RE: Response to Applicant's Experts on Hydrogeologic Evaluation of Irrigation Water Supplies for Canna Rios Cannabis Production Project, 3205 White Rock Lane, Santa Maria, CA; APN 129-040-010

**Re:** Appeal of Planning Commission Approval  
Canna Rios LLC - Outdoor Cannabis Cultivation (19LUP-00000-00116)  
Grading Code Violation

Figure R2. Annotation of Walch (2021) Figure 6 showing corrected top of Paso Robles formation at the Canna Rios Well #2 location.

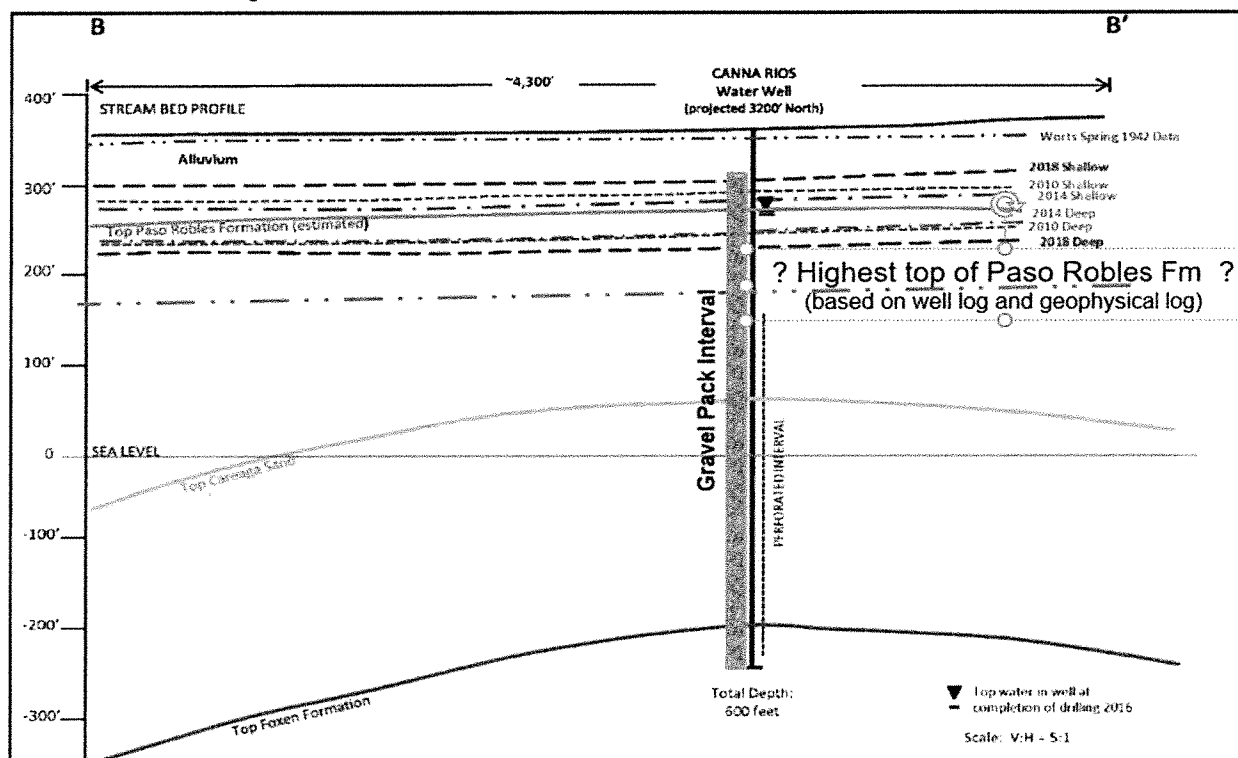
strongly disagree, however, with the interpretation by Walch (2021) that the recent alluvium is only 25 feet thick at that location. In fact, based on the driller's log, it appears that the Paso Robles is encountered at a depth no shallower than 185 feet. The recording of "streaks of white clay" in the descriptions from a 185-foot depth to the 306 feet is suggestive of the Paso Robles formation. However, even below the 306-foot depth, the descriptions of the material colors and clast descriptions are more consistent with recent alluvium than Paso Robles formation. Thus, my opinion is unchanged that the top of the Paso Robles formation at Well #2 is no shallower than 185 feet below ground surface (BGS), and it could go beyond the 300-foot depth. To better characterize the top of the Paso Robles would take a more detailed investigation employing multiple well logs from the vicinity, in an ideal world augmented by cuttings collected during drilling if possible.

Based on my interpretation of the geologic log and the geophysical log, I have annotated Walch's (2021) Figures 6 and 7 to show a more defensible interpretation of the Paso Robles top surface, as shown in **Figures R2** and **R3** below. The groundwater levels shown from the original Walch figures were checked and verified, and thus are unchanged in my annotated figures. The critical item to note in these figures is that the Well #2 sandpack extends well up into the saturated portion of the connected alluvial sediments. Thus, the conceptual model presented as **Figure 6** in my original report remains the same: connected alluvial groundwater will be drawn into the sandpack and flow downward to the well intake screen, to be produced at the surface as a major component of the overall well discharge.
